HARVEST VALLEY COURT P.U.D.

FINAL PLAT AMENDMENT

CITY COUNCIL MEETING

Summary: Cory Waddoups of Unreasonable Capital Hyrum is seeking City Council approval for the amendment of a final plat for a Planned Unit Development for a 55+ senior community.

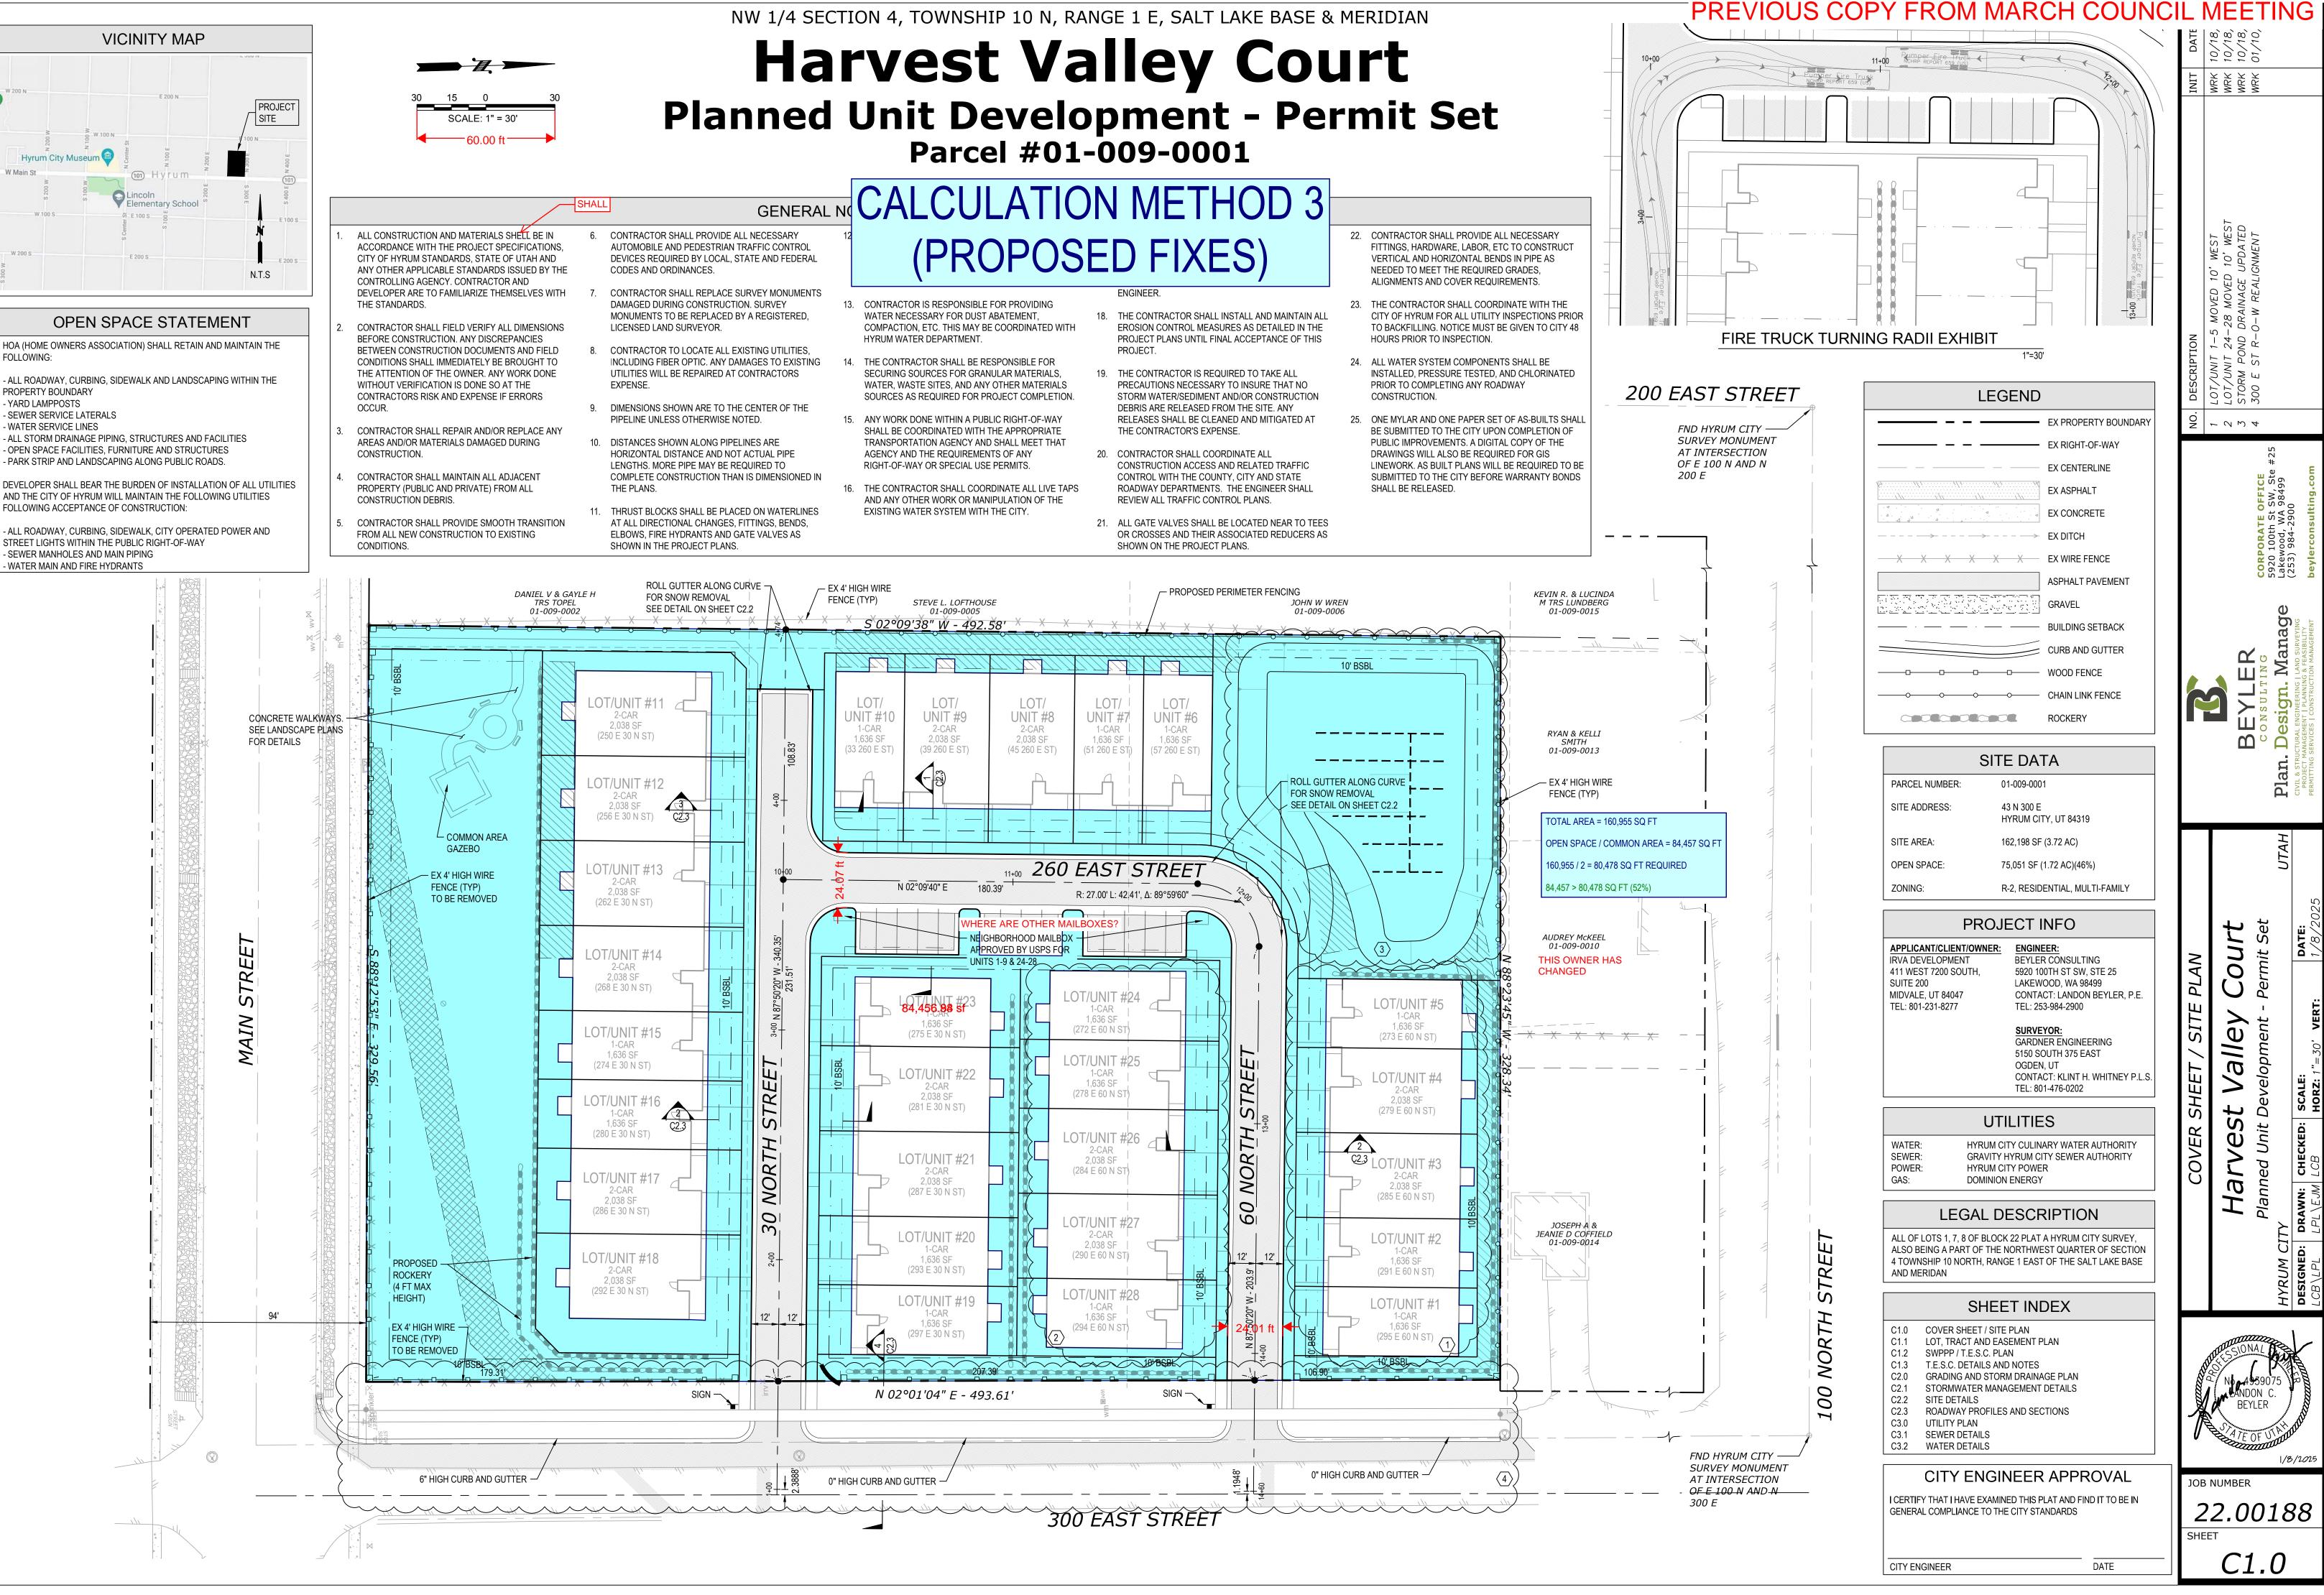
The developer in coordination with the City is seeking to amend the plat to adjust the east boundary of the plat to reflect the accepted city right of way. The significant changes to this include shifting away from the east boundary to meet the 10-foot setback.

- The applicant has prepared an exhibit showing the changes to lot lines to provide more open area.
- Lot lines and building envelopes for Lots 24-28 have been adjusted to make the lines and building areas consistent with each other.
- The property boundaries for Lots 23 and 24 have been adjusted to exclude the sidewalk along 260 East.
- Lot lines have been reduced to the building envelope to put more land in open area.
- A new landscape exhibit has been provided
